Stage 1 Road Safety Audit.  
Church Street Junction Improvements,  
Athlone.

Report

Job No. ST17466

Date 07 November 2016

TITLE:  
GENERAL ARRANGEMENT PLAN  
Sheet 1 of 2  
**DRAFT**

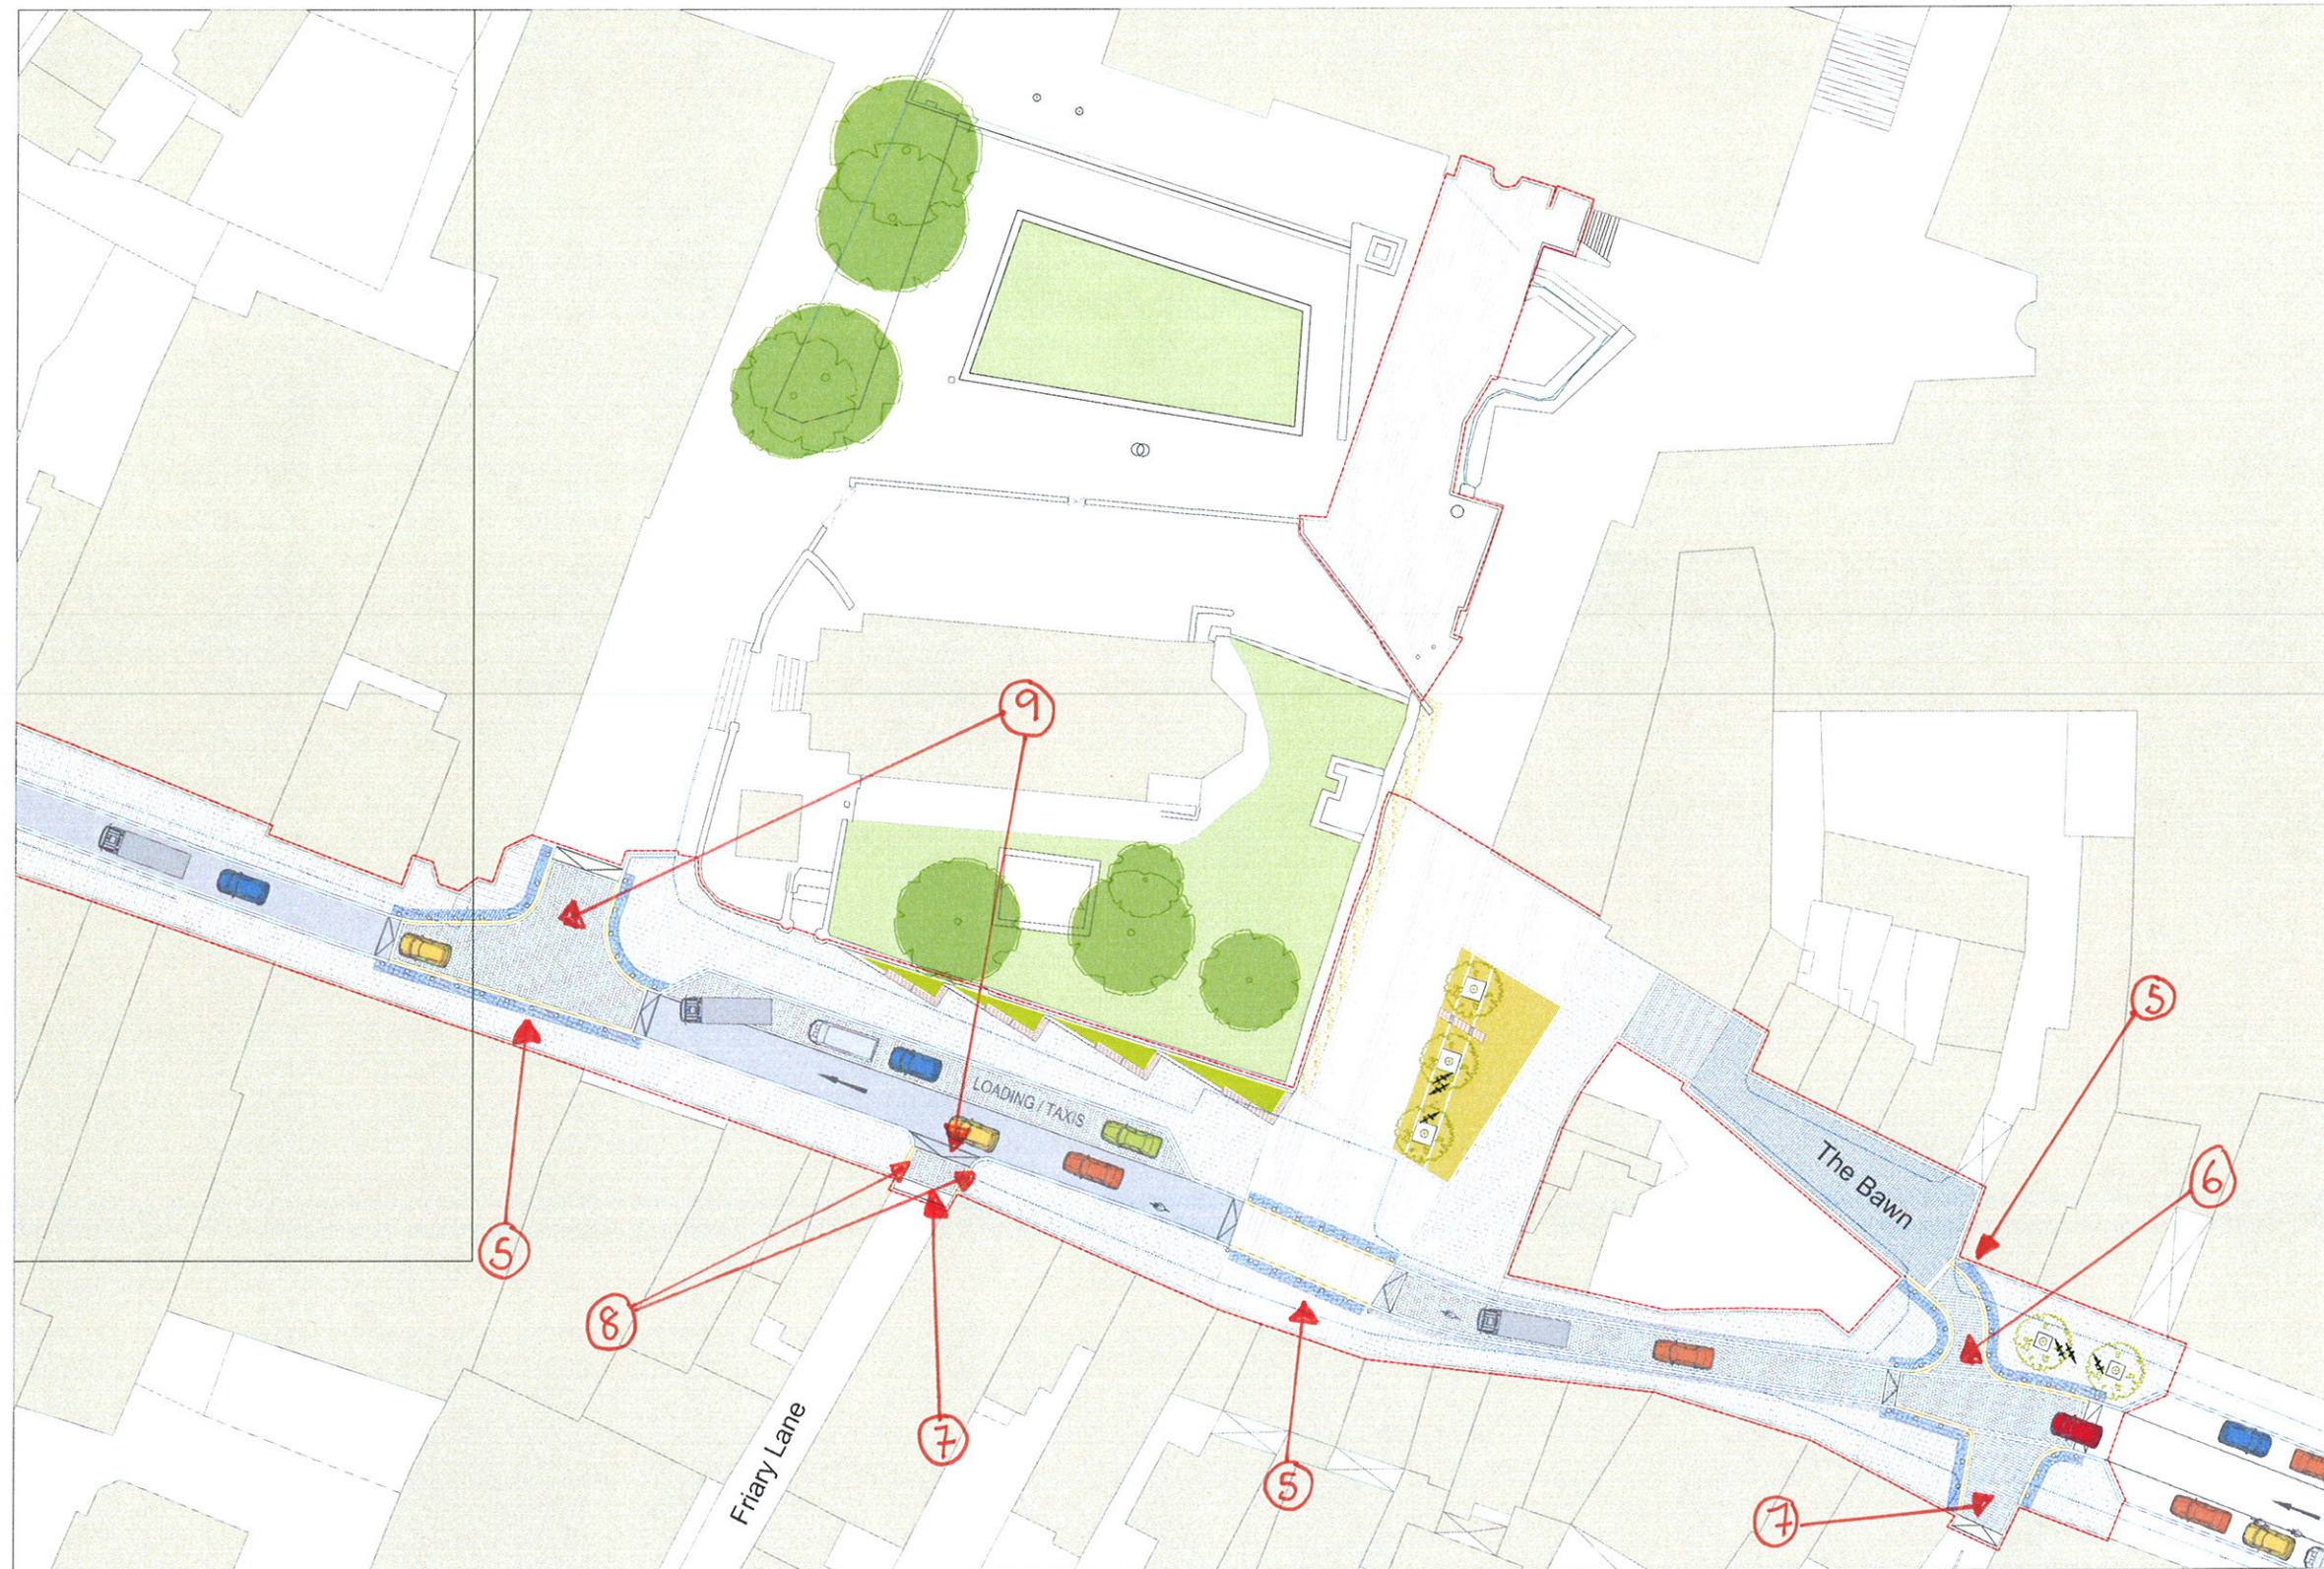
Location: 5 – All bollards provided along Church Street.

Summary: Lack of contrasting band, risk to visually impaired pedestrians.

Numerous steel bollards are proposed along Church Street to control vehicle and demark the safe footway areas where raised tables have been provided. It is not clear if the proposed bollards will incorporate a contrasting coloured strip to help identify them to visually impaired pedestrians. If the bollards do not contain a contrasting coloured strip it will be difficult for visually impaired pedestrians to see the bollards and this will increase the risk of them waking into them, or tripping over them, causing the pedestrian an injury.

Location: 6 – The Bawn.

Summary: Narrowing of junction and carriageway with bollards, risk of large vehicles striking bollards.

The existing carriageway and junction area at The Bawn is being reduced in width with the introduction of a raised table and bollards to identify the limits of where vehicles should proceed. The area provided to access The Bawn looks very tight and vehicles may struggle to enter and exit The Bawn without striking the bollards around the junction area.

Location: 10 – Northern side of Church Street.

Summary: Planters may obstruct small children, increasing the risk of them stepping into path of car and being struck and also increase the risk of pedestrians becoming stuck between a vehicle and the carriageway increasing the severity of injury if struck.

There are 4 proposed planters along the northern side of Church Street that abut directly up to the edge of the running carriageway. The height of the planters is not shown on the drawings, but seating is shown on some sides of the planters indicating that they could be of sufficient height to hide small children from approaching vehicles increasing the risk of them stepping out into the carriageway and being struck by a vehicle.

The planters also increase the risk of a pedestrian becoming trapped or stuck between the planter and a vehicle travelling along Church Street, or turning out of Bridge Street, increasing the risk and severity of any collision of this type that occurs.

The western most planter will also obstruct the intervisibility zone at the signal junction increasing the risk of a vehicle turning northwards towards Northgate Street and striking a pedestrian on the crossing.

It is recommended that all proposed bollards have a strip of contrasting colour around them to help visually impaired pedestrians see the bollards.

It is recommended that the swept path of all vehicles that are anticipated to access The Bawn are checked to ensure they can safely enter and leave The Bawn within the new carriageway space provided for them.

It is recommended that the planters are set back from the carriageway edge by 800mm and the row of tactile paving with inset bollards is continued along the edge of the carriageway to allow some space for children to be seen before entering the carriageway and to provide some protection to pedestrians from becoming trapped between the planters and a vehicle.

The height of the western most planter should be checked to ensure that it does not obstruct the intervisibility zone at the signal junction and moved or lowered if required.
